Soorty Textiles (BD) Ltd. (Extension)

30 November 2023

Structural Inspection Report

Building-1

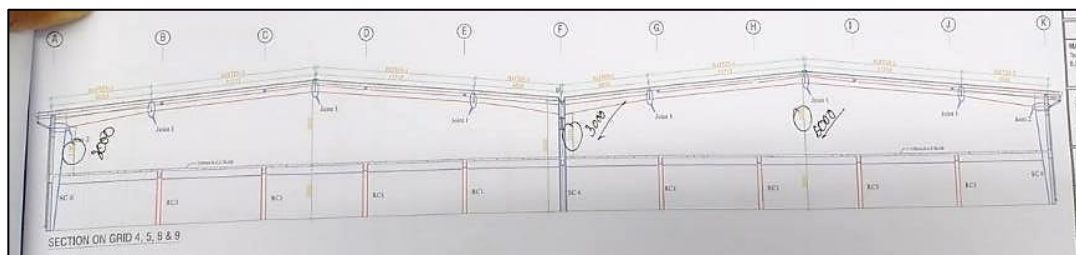
Observation-1: Detail review against lateral forces is required for the prepared design documents (design report, floor load plan, retrofitting scheme). (Building-1)

Description: A set of design documents was available onsite which are to be submitted to RSC for detailed review against lateral forces. Revise the design documents based on in-situ & retrofitting material strength. Submit to the RSC for review.

Item No.	Observation	Action Plan	Timeline
1.	Detail review against lateral forces is required for the prepared design documents (design report, floor load plan, retrofitting scheme). (Building-1)	The building engineer is required to revise the design report based on in-situ/retrofitting material strength & software-based analysis and submit the documents to RSC for review.	within 6 weeks

Observation-14: Non-engineered extension next to Building-2 not included in the design report.

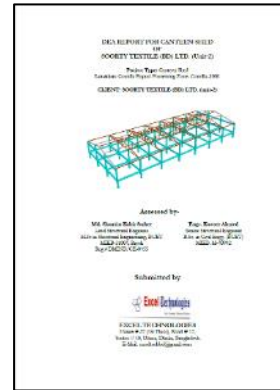
Description: Non-engineered extension next to Building 2 is not included in the design report. The building engineer is to prepare the design document & carry out necessary remedial works for the extension, otherwise demolish it.

16.	Non-engineered extension next to Building 2 is not included in the design report.	The building engineer is to prepare the design document & carry out necessary remedial works for the extension, otherwise demolish it.	within 6 months
